**STRATEGIC PETROLEUM RESERVE
ENGINEERING CHANGE PROPOSAL**

ECP NUMBER SJ-M/O-4632 TITLE Replace and re-pin Legs on Tanks 3, 4, 5, & 6

ECP NUMBER SJ-M/O-4632		ECP TITLE Replace and re-pin Legs on Tanks 3, 4, 5, & 6		PAGE 1 OF 4	
CONTRACTOR CHANGE NO. / REV.		INITIATED BY Doug Cloud	DATE 1/22/03	SUBMITTED BY Jill Derise	DATE 1/22/03
PRIORITY <input type="checkbox"/> EMERGENCY <input type="checkbox"/> URGENT <input checked="" type="checkbox"/> ROUTINE		ORG / CONTRACTOR Shell Pipeline Company LP	PHONE NO. (504) 728-7131	ORG/CONTRACTOR Shell Pipeline Company LP	PHONE NO. (504) 728-7366
VALUE ENGINEERING <input type="checkbox"/> VEP (MANDATORY) <input type="checkbox"/> VEP (VOLUNTARY)		DRAWDOWN CRITICAL <input type="checkbox"/> YES <input checked="" type="checkbox"/> NO		ROM ESTIMATE \$ <u>270,000</u>

TANK 1 SUGARLAND
 ROOF SUPPORT LEGS
 TOTAL OF 205 LEGS

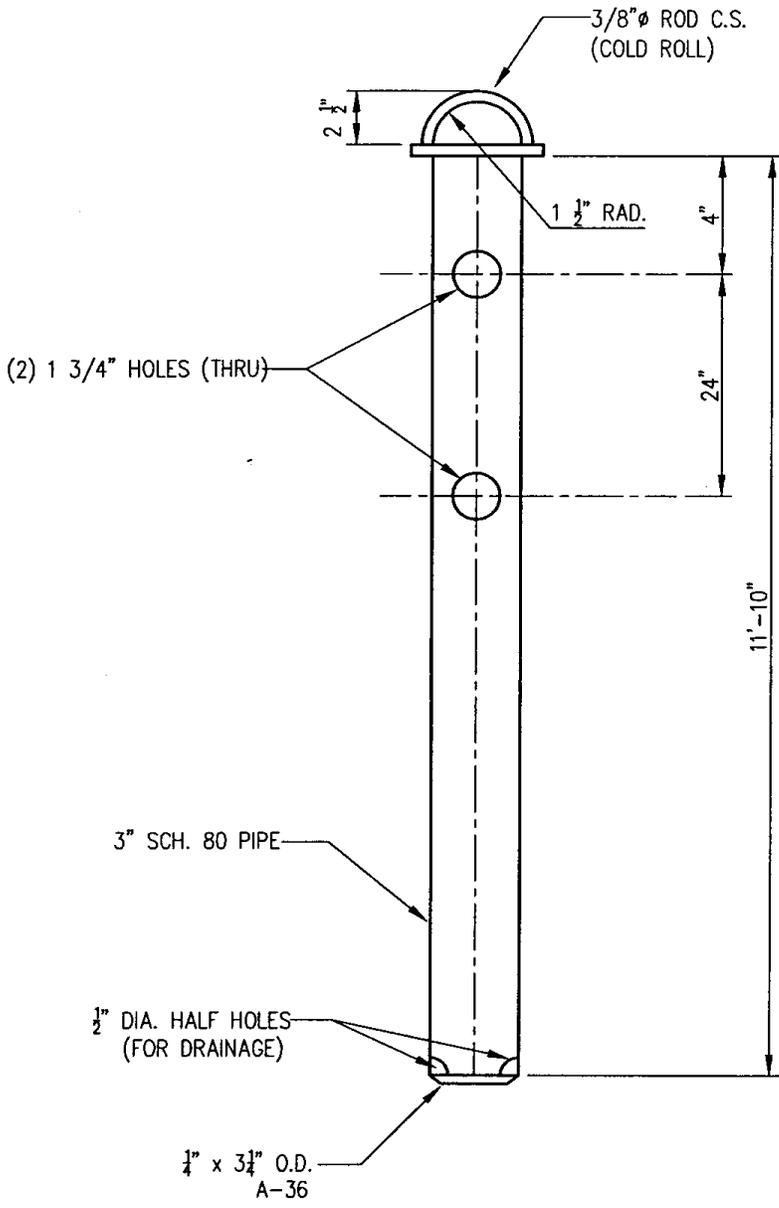
This ECP is being submitted as documentation of work that was done at Sugarland in 2000. The legs and leg sleeves on Tanks 3, 4, 5, & 6 were corroded and required replacement and repair, respectively. A second pin and pin hole was installed in the sleeve for added strength.

Purchased legs, re-drilled sleeve pins, and installed the new legs. Legs are 3" O.D. x 12' long Schedule 80 steel with end caps. See attached drawing.

COMPLETED ASSYMBLYS TO BE HOT DIP GALVANIZED
 ZINC COATING TO AVERAGE (3) OZ. PER SQUARE FOOT.
